<b>TITLE</b> <i>IMPROVE AIR CLEANINESS IN DISK CAVITY</i>				PIB NO. DK3073	
PRODUCT LINE:	TAPE DISK FORMATTER <input checked="" type="checkbox"/>	EQUIPMENT CHANGED <i>Lower Disk Cover</i>	MODEL SERIES AFFECTED D3XXX	EFFECTIVE DATE 2/1/78	
CLASS OF BULLETIN:		ORDER PART KIT NO.	EFFECTIVITY		
<input checked="" type="checkbox"/> IMPROVEMENT		108120-01	All D3000 Top and Front Load Excluding the D3000 Extension.		
<input type="checkbox"/> RETROFIT ON FAILURE		TIME REQUIRED			
<input checked="" type="checkbox"/> RETROFIT RECOMMENDED		½ Hr.			
<input type="checkbox"/> SERVICE INFORMATION ONLY					
<b><u>PURPOSE:</u></b> To inform Disk customers that baffling the head opening port is an effective technique to pressurize the Disk cavity, therefore reducing contamination.					
<b><u>SYMPTOMS:</u></b> Excessive head crashes contributed to environments not complying to "clean room" standards.					
<b><u>PARTS REQUIRED:</u></b>

TITLE *IMPROVE AIR CLEANINESS IN DISK CAVITY*

PIB NO.  
DK3073

(FIGURE 1)

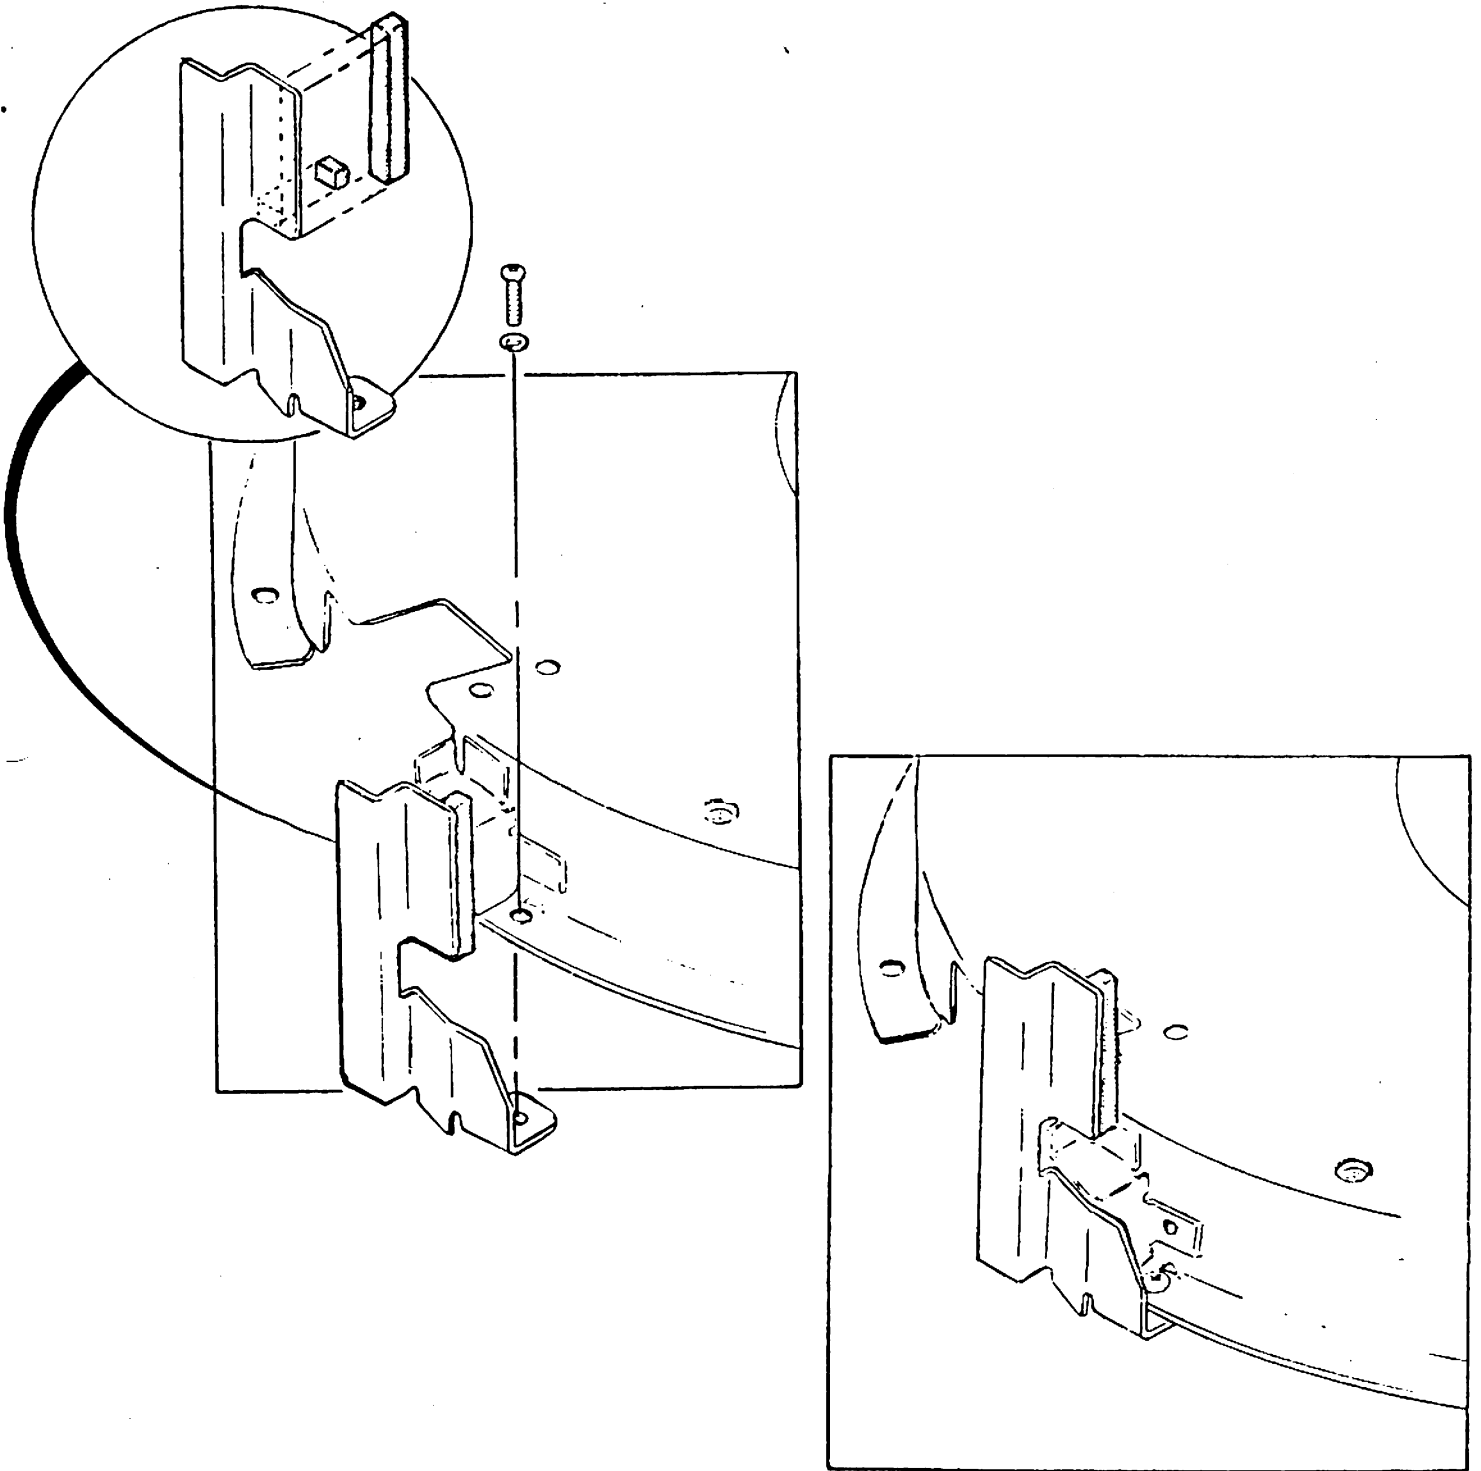
<u>Qty</u>	<u>Nomenclature</u>	<u>Pertec P/N</u>			
1	Baffle Kit Assy.	108120-01			
<b><u>SPECIAL TOOLS REQUIRED:</u></b> NONE					
<b><u>INSTALLATION PROCEDURE:</u></b> (See figure 1)

1) Remove power from unit.					
2) Raise Logic PCBA.					
3) Locate Hole in lower Disk Cover adjacent to white Disk Guide.					
4) Install Baffle as per Figure 1.

a. Slip lower lip of baffle underneath the hole located in step 3.					
5) Install phillips head screw (10-32X5/16) with lock washer.					
<b><u>ADJUSTMENTS:</u></b>

1) Bending and or adjustment of the Baffle may be necessary to ensure a snug fit of the foam against the Lower Disk Cover.					
2) Verify that the Bail Door Opener (P/N 102624) can be moved throughout its range without interference.
